N2830A-01

# Modification Recommended Service Note

## N2830A 4 GHz InfiniiMax III+ Series Probe Amplifier

Serial Numbers: US00000000 / US57270000

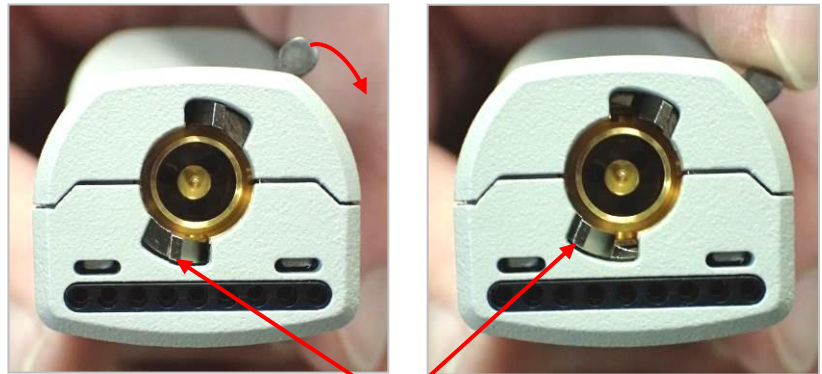
If the set screw is not stainless, it looks like the following after the sticker has been removed:

- If the screw is stainless, then remove adhesive and replace the label.
- No need to re-calibrate.
- If screw is black remove screw using T6 Torx.

Replace the current set screw under the product label to ensure cable ground connection to BNC ground.

**BNC tab rotates with BNC latch rotation**

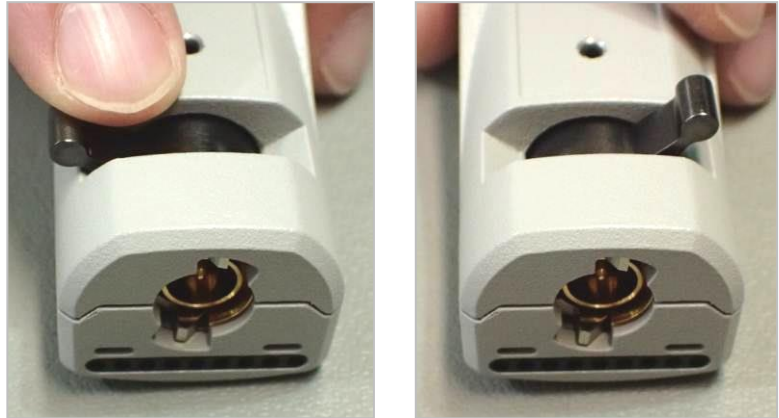
Below is what the new set screw should look like when inside the probe.

Install screw 0515-5534 Tighten T6 to 18 in oz.

Test the BNC connector by rotating the wing latch **clockwise**, and verify the BNC tab rotates inside the pod housing.
